July 3, 1986

WISCONSIN PUBLIC SERVICE CORPORATION
WISCONSIN POWER AND LIGHT COMPANY
MADISON GAS AND ELECTRIC COMPANY
DOCKET NO. 50-305
KEWAUNEE NUCLEAR POWER PLANT
AMENDMENT TO FACILITY OPERATING LICENSE

Amendment No. 67
License No. DPR-43

SAFETY EVALUATION BY THE OFFICE OF NUCLEAR REACTOR REGULATION
RELATED TO AMENDMENT NO. 67 TO FACILITY OPERATING LICENSE NO. DPR-43

Figure 1
Existing Configuration of Offsite Power
Supplies to KNPP Substation

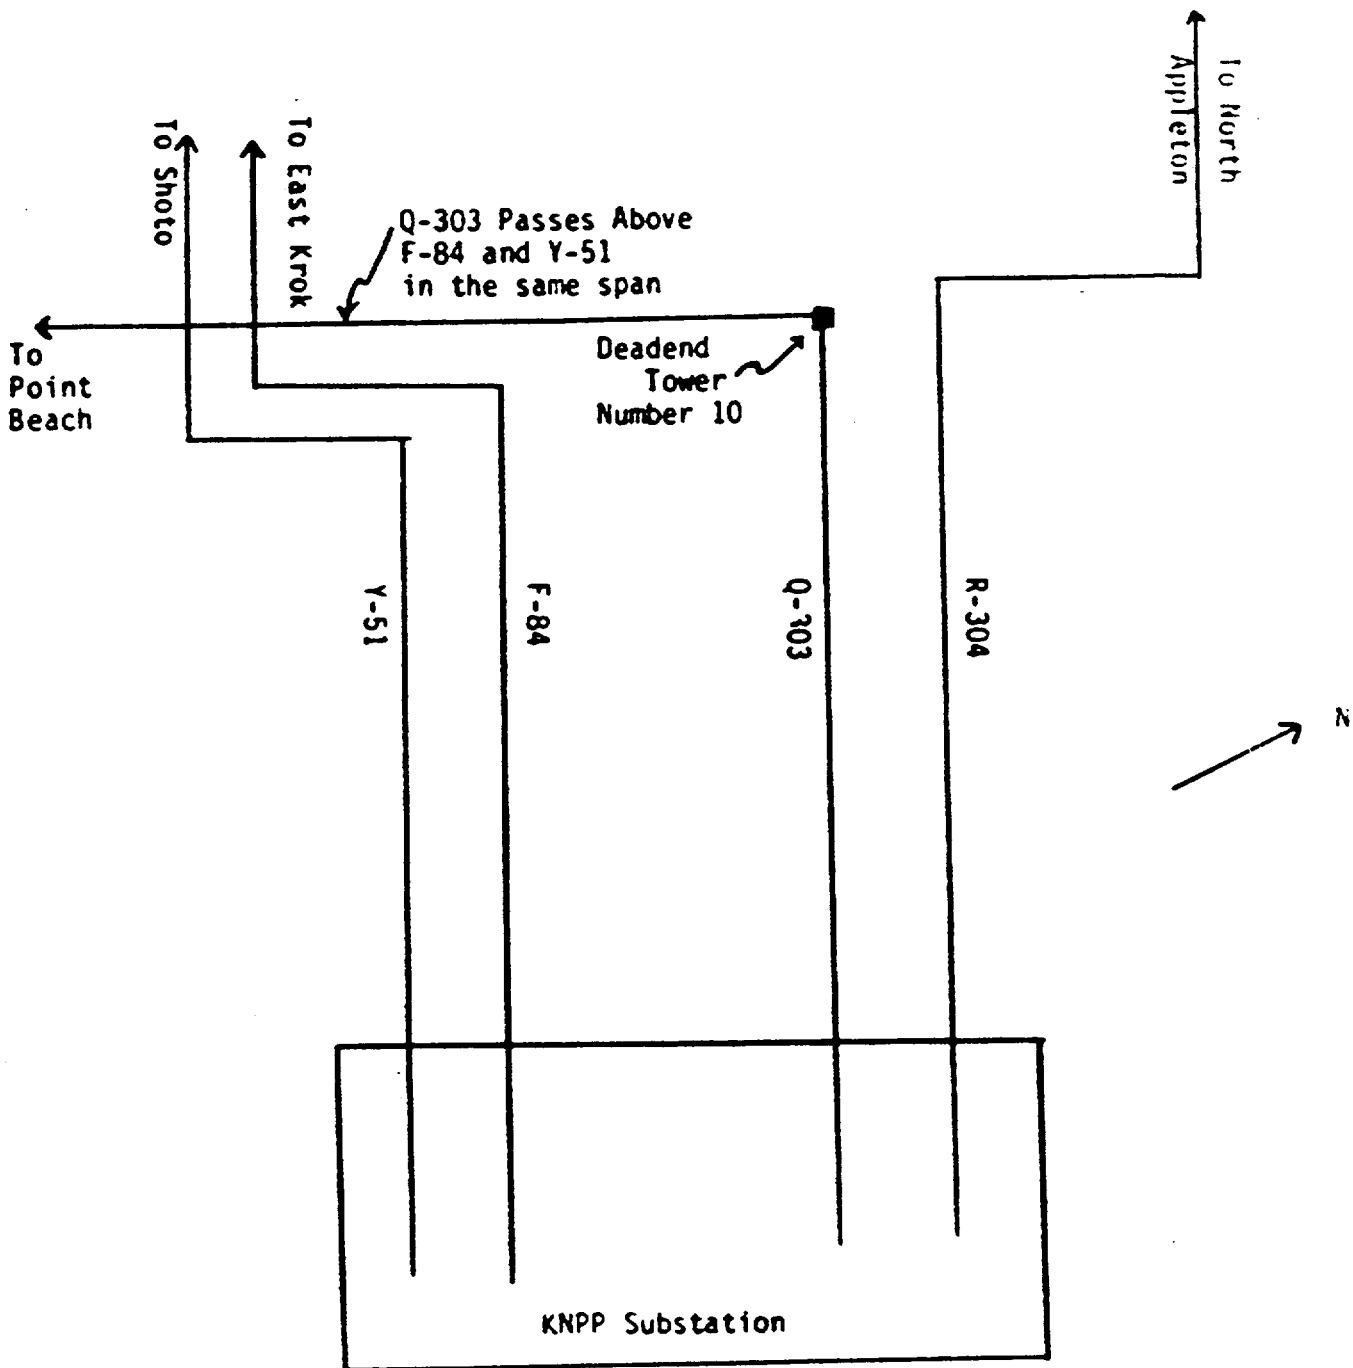
The KNPP TS require that two physically independent offsite power sources be operable to serve the KNPP substation in accordance with General Design Criteria 17 of 10 CFR Part 50, Appendix A. The KNPP substation is presently fed by four offsite sources; however, one of the four power lines (Q-303, 345 KV) passes above two of the other offsite power lines (F-84, 138 KV and Y-51, 138 KV). It can then be postulated, that a single failure of Q-303 at this point could affect all three lines leaving only one offsite power line R-304 (345 KV), the North Appleton Line, operational. The possibility of losing three of the four lines in one accident has required a TS limiting condition of operation (LCO), 3.7.b.4, which limits the time that the North Appleton Line can be out-of-service to seven days when two other lines are in service.

In order to increase the reliability of offsite power to KNPP, the licensees have proposed rerouting one of the four lines (F-84) so that the possibility of one line causing failure in three lines is eliminated. The new route of line F-84 passes under line Q-303 at a different crossing than line Y-51, see Figures 1 and 2 for existing and proposed routing changes. The routing change will make three, two line combinations, physically independent:

The physical independence of the F-84 and Y-51 pair in the proposed reroute is based upon the assumption that a catastrophic failure of line Q-303 will not be extended past Deadend Tower No. 10 and, therefore, would only affect one of the two lines. The licensees state that their assumption is based upon service data for deadend towers in their systems. They have not experienced a structural or insulator type failure that has been extended through a 345 KV deadend tower in 545 tower years. Indicating a failure rate of less than 0.00183/yr for this type of tower and this probability is compared to all U.S. nuclear plant power outages of less than 30 minutes which have a probability of 0.044/yr.

The staff has reviewed the above rerouting proposal and agree that the offsite power reliability for the KNPP would be enhanced by eliminating the crossing which could result in a Q-303 line failure removing two other lines from service. The staff also reviewed proposed LCO (3.7.a.8) which requires one pair of lines be operable and specifies the three pairs of offsite lines that are physically independent and the action statement (3.7.b.4) which will eliminate the reference to the North Appleton Line as the only physically independent line. The staff finds these changes to be acceptable.
